SUNDRY NOTICES AND REPORTS ON WELLS
Do not use this form for proposals to drill or to re-enter an abandoned well. Use Form 3160-3 (APD) for such proposals.

PROPOSED PROCEDURE FOR PLUG AND ABANDONMENT:

Cimarex Energy Co. of Colorado
Pipeline A8 Federal 2
 API 30-025-35632
 660 FSL & 660 FEL, Sec 8, T19S R34E
 Lea County, NM
 GL: 3785' KB: 3805'

Current wellbore diagram

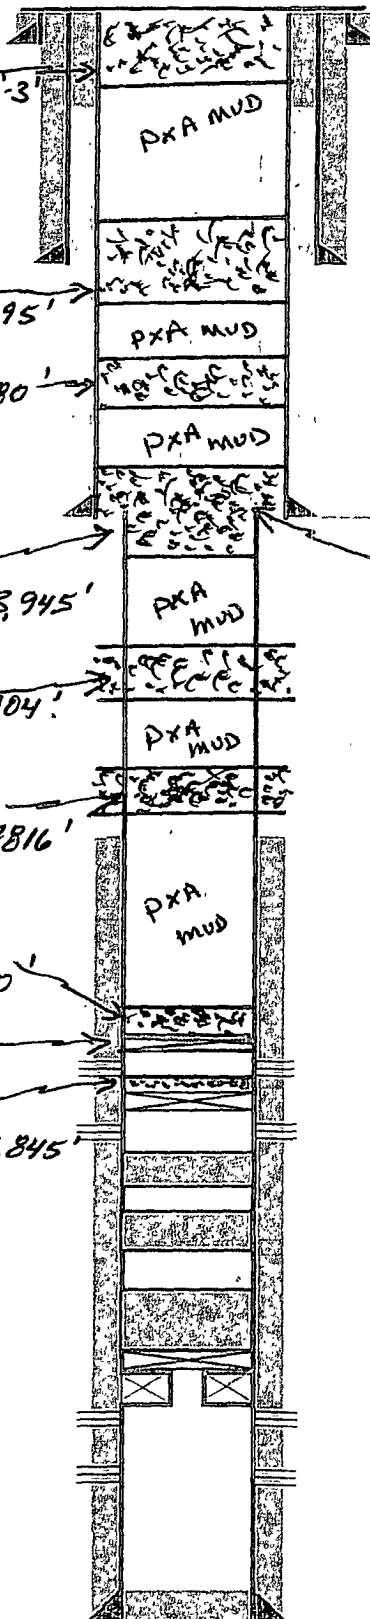
Rec F 55 sxs. cmt. @ 6,054'-5,904'

Rec F 60 sxs. cmt. @ 7,976'-7,816'

TOC 1700

BOC 3190
yds 3350

5 1/2" csg. cut

Del. 5979

BS 7876

WC 10835
CICO 11872
CYN 12062
ST 12155

AT 12423

MR 12913

MISS 13523
